### DXi9000 Series Release Notes 4.5.0.4

### **Purpose of This Release**

DXi 4.5.0.4 Software is a release supporting DXi9000/9100 disk backup systems that may contain 12 G Quad-port SAS cards in Node Slots 2 and 3.

### Node Rear Views with New Quad-port SAS Cards

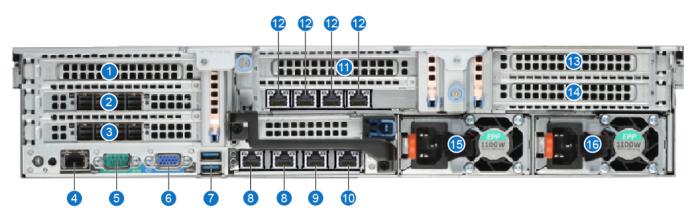
New DXi9000 SD, HD, and DXi9100 systems shipped with DXi Software Release 4.5.0.4 may include 12 G Quad-port SAS cards in Node slots 2 and 3, replacing the previously used 12 G Dual-port cards.

**Note:** This numbering varies from the existing cards in DXi9000 Series Nodes, which are numbered left-to-right.

**()** Note: Port numbers are etched into the cards near the port activity indicators.

### DXi9000 SD - Cable the Node to the Array Module (RBOD)

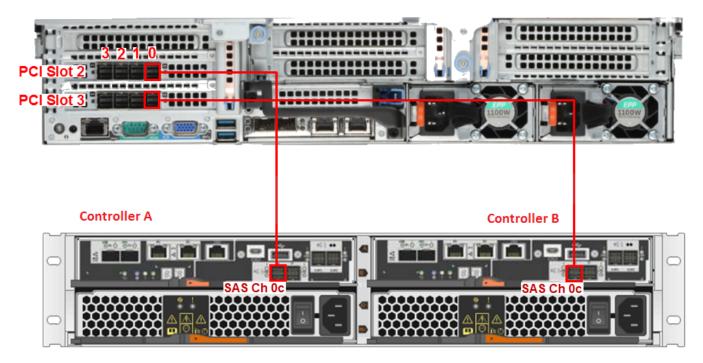
Node		Array Module (RBOD)
Connect PCI Slot 2 - Port 0 (far-right port)	$\rightarrow$	Controller A - SAS Ch 0c
Connect PCI Slot 3 - Port 0 (far-right port)	$\rightarrow$	Controller B - SAS Ch 0c

## DXi9000 HD - Cable the Node, Array Module (RBOD), and Expansion Module (EBOD)

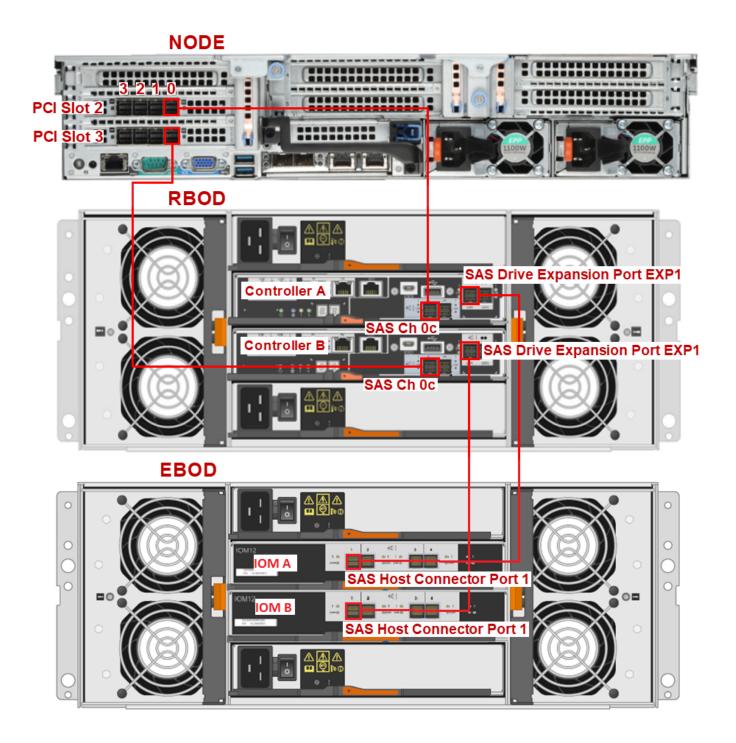
Node		Array Module (RBOD)
Connect PCI Slot 2 - Port 0 (far-right port)	$\rightarrow$	Controller A - SAS Ch 0c
Connect PCI Slot 3 - Port 0 (far-right port)	$\rightarrow$	Controller B - SAS Ch 0c

Array Module (RBOD)		Expansion Module (EBOD)
Connect Controller A - SAS Drive Expansion Port EXP1	$\rightarrow$	IOM A - SAS Host Connector Port 1
Connect Controller B - SAS Drive Expansion Port EXP1	$\rightarrow$	IOM B - SAS Host Connector Port 1

#### DXi9100 Cabling: Node + 2 Array Modules

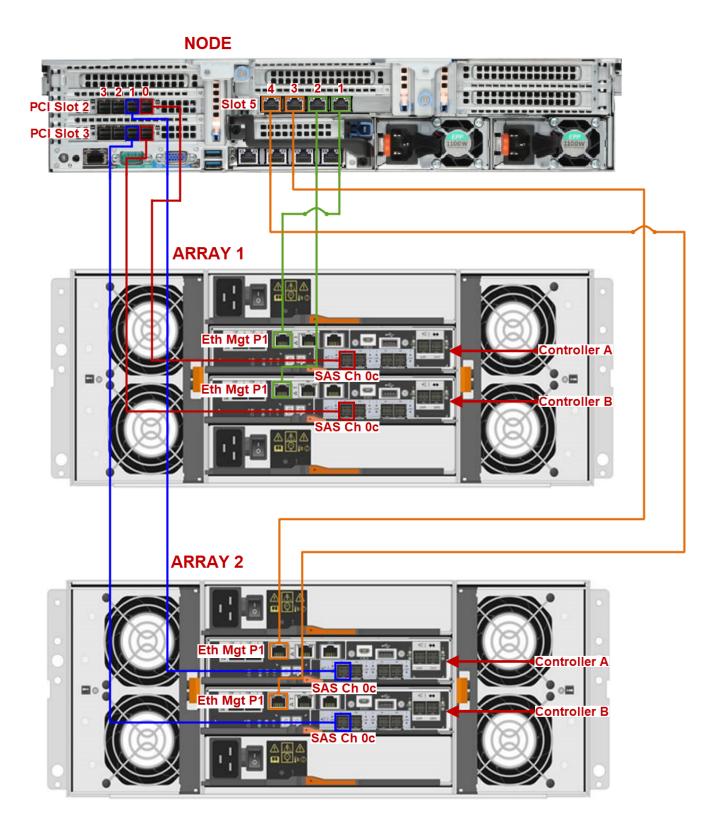
Node		Array Modules
Connect PCI Slot 2 - Port 0 (far-right port)	$\rightarrow$	Array 1 Controller A - SAS Ch 0c
Connect PCI Slot 3 - Port 0 (far-right port)	$\rightarrow$	Array 1 Controller B - SAS Ch 0c
Connect PCI Slot 2 - Port 1 (second from right)	$\rightarrow$	Array 2 Controller A - SAS Ch 0c
Connect PCI Slot 3 - Port 1 (second from right)	$\rightarrow$	Array 2 Controller B - SAS Ch 0c
Connect Slot 5 - Port 1	$\rightarrow$	Array 1 Controller A - Ethernet Management Port 1
Connect Slot 5 - Port 2	$\rightarrow$	Array 1 Controller B - Ethernet Management Port 1
Connect Slot 5 - Port 3	$\rightarrow$	Array 2 Controller A - Ethernet Management Port 1
Connect Slot 5 - Port 4	$\rightarrow$	Array 2 Controller B - Ethernet Management Port 1
